## CITY OF LINCOLN/LANCASTER COUNTY PLANNING STAFF REPORT

**P.A.S.:** Ridge Pointe 2<sup>nd</sup> Addition Final Plat No. 02030      **DATE:** October 17, 2002

**PROPOSAL:** A final plat consisting of 41 lots and 1 outlot.

**To:** Jason Reynolds, Planning Department  
**From:** Charles W. Baker, Public Works and Utilities *hwb*  
**Subject:** Ridge Pointe 2nd Addition Final Plat #02030  
**Date:** July 2, 2002

# RIDGE POINTE 2ND ADDITION

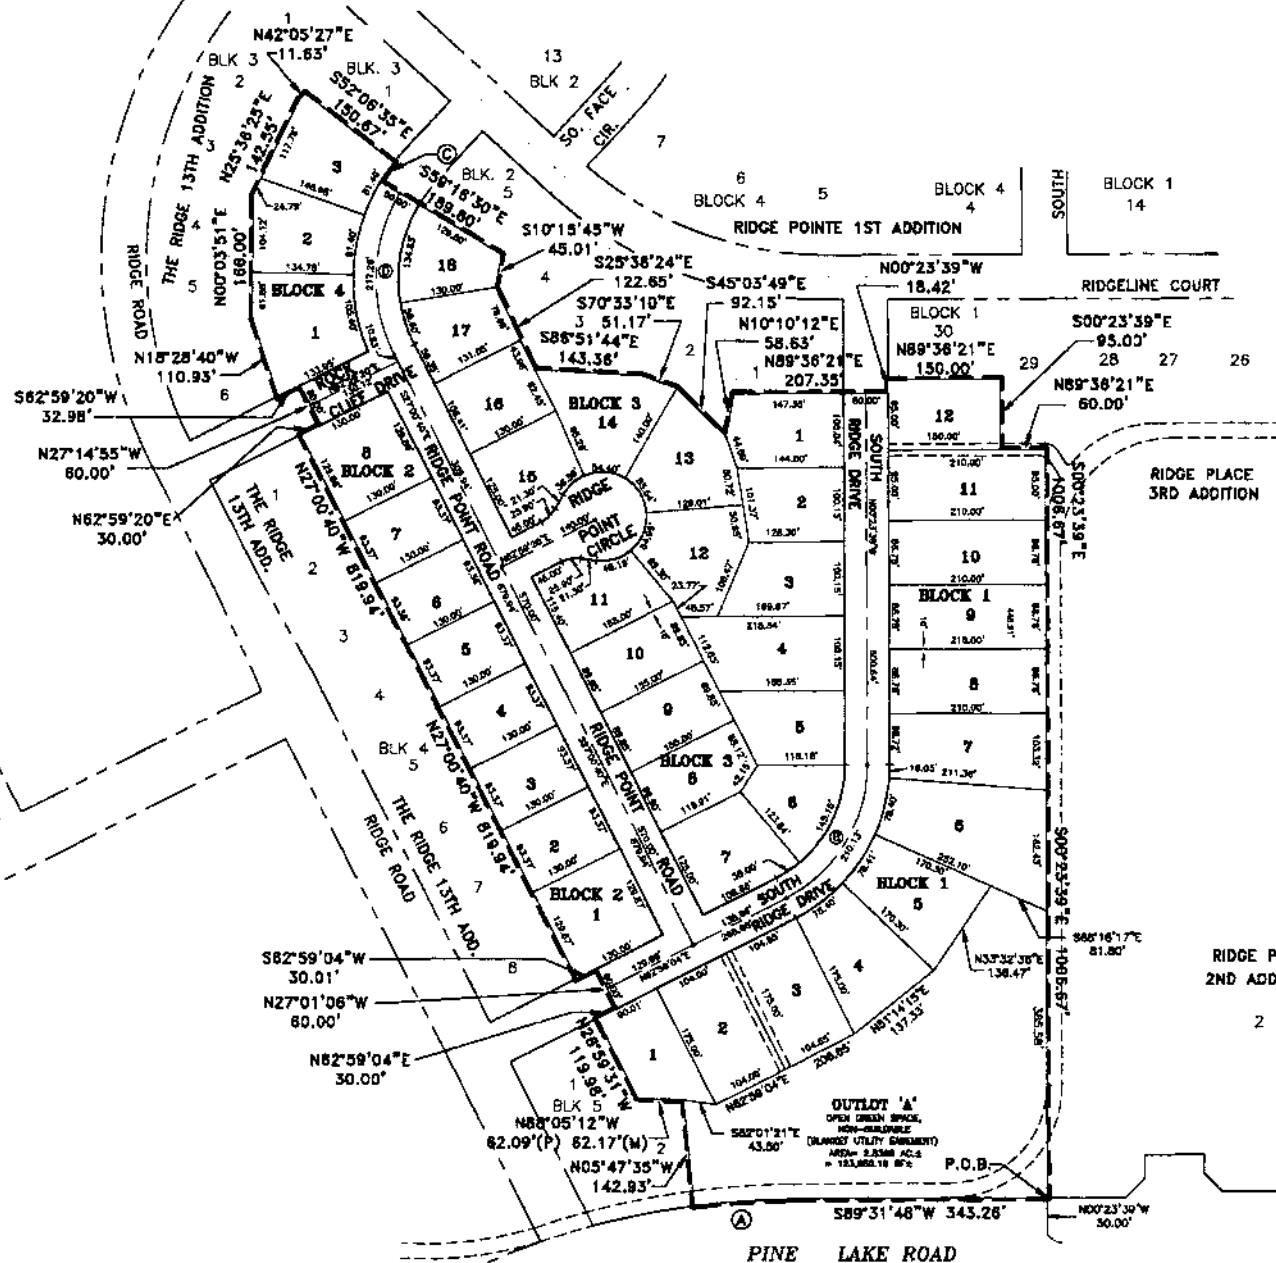
- Sidewalks - A \$6,100 bond should be required for the construction of the sidewalks within this addition. The pedestrian easement must be shown on the plat. An additional \$8,000 will be required for the pedestrian/bike trail.
